Re: NERT Response to NDEP June 27, 2013 Comments on the Remedial Investigation and Feasibility Study Work Plan; Nevada Environmental Response Trust Site, Henderson, Nevada; dated December 17, 2012 (NDEP Facility ID #H-000539)

**Response to NDEP Comments on
Remedial Investigation and Feasibility Study Work Plan
Nevada Environmental Response Trust Site, Henderson, Nevada
Dated December 17, 2012**

**Figure: Site Boundary, Sale Parcels, and Tronox-Leased Area Acreage
*Nevada Environmental Response Trust Site, Henderson, Nevada***

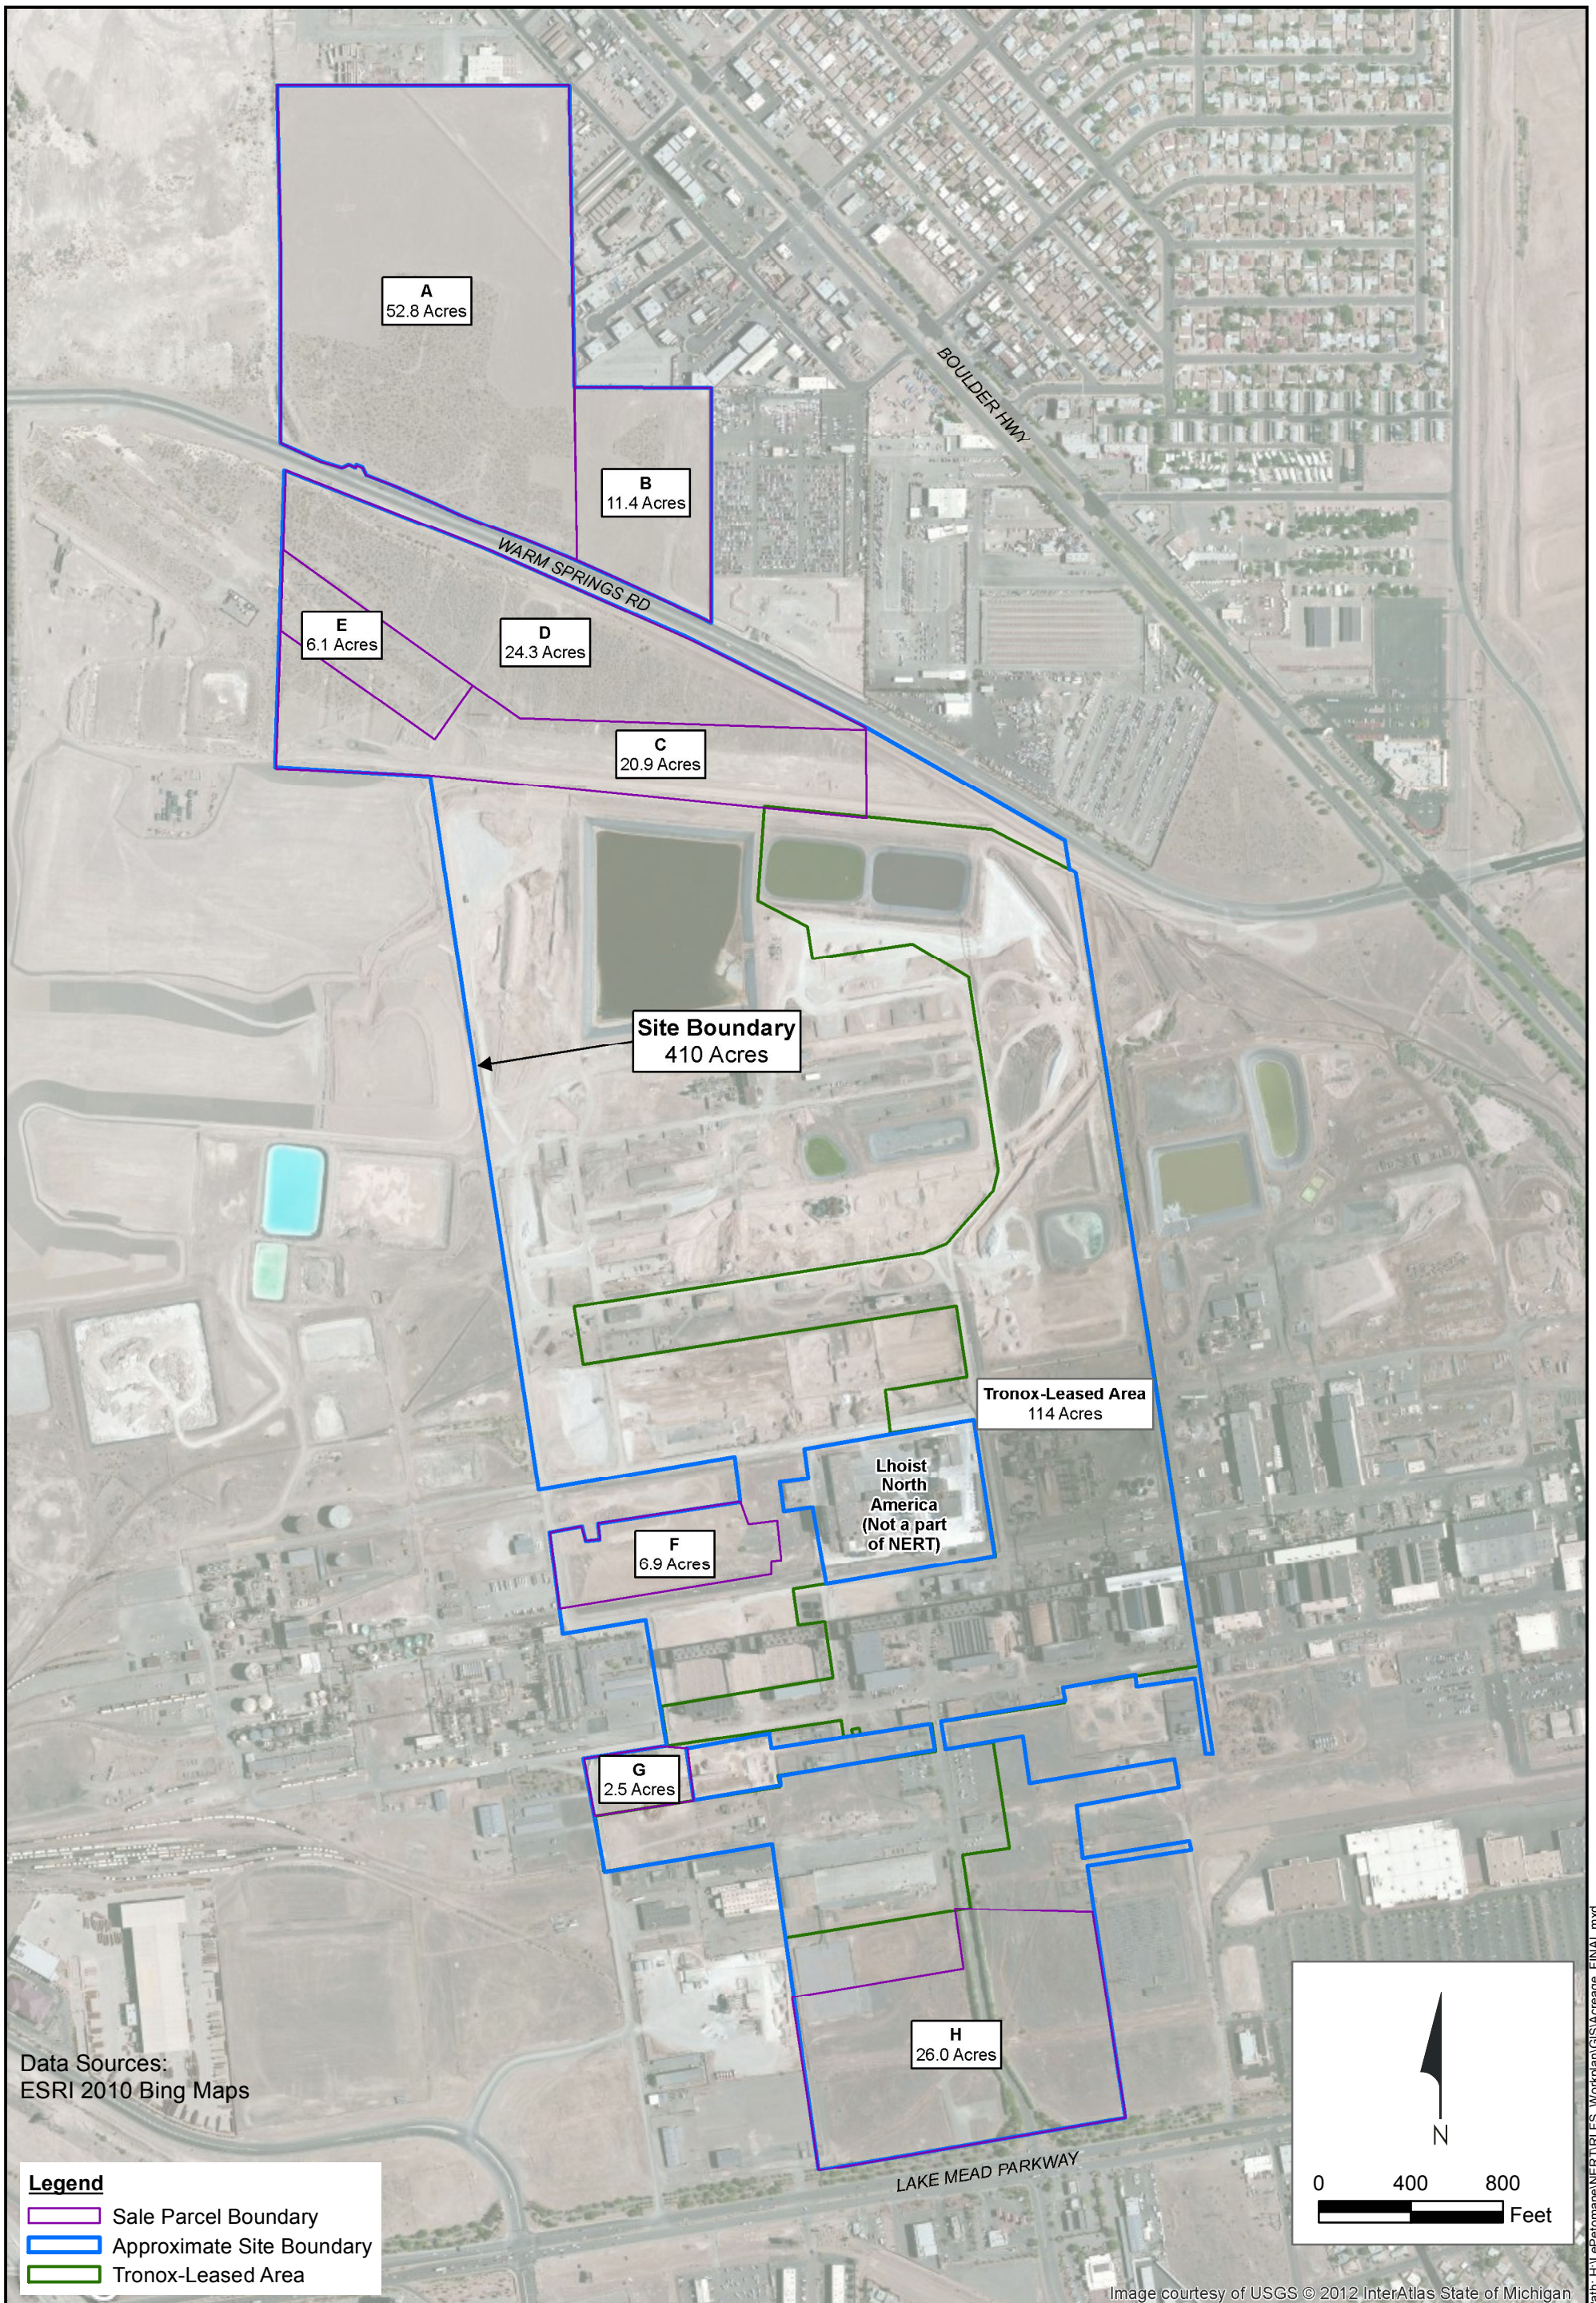
NDEP Comment	Response
<p>11. Section 2.1 Operational History, page 4, second paragraph, the Deliverables states that the 373 acres are leased to Tronox LLC. Please check the number of acreage for the NERT property, parcels proposed to sell and the leased area and make sure that they are accurate and consistent in all Deliverables.</p>	<p>The acreage of the Tronox-leased area has been checked and determined to be approximately 114 acres. The Trust property, including the Tronox-leased area and sale parcels, is 410 acres. The sale parcels A-H (except E) consist of approximately 145 acres, with approximately 64.2 acres located north of Warm Springs Road (Parcels A & B), 45.2 acres south of Warm Springs Road and north of the GW-11 and WC ponds (Parcels C & D), and 35.4 acres south of Avenue F (Parcels F, G, and H). The acreage of the Tronox-leased area will be corrected in the revised RI/FS Work Plan, and the property sizes noted here will be consistently provided in all future deliverables. In addition, the attached figure showing the acreage of the Trust property, including the Tronox-leased area and sale parcels, will be included in the revised RI/FS Work Plan (Attachment B).</p>
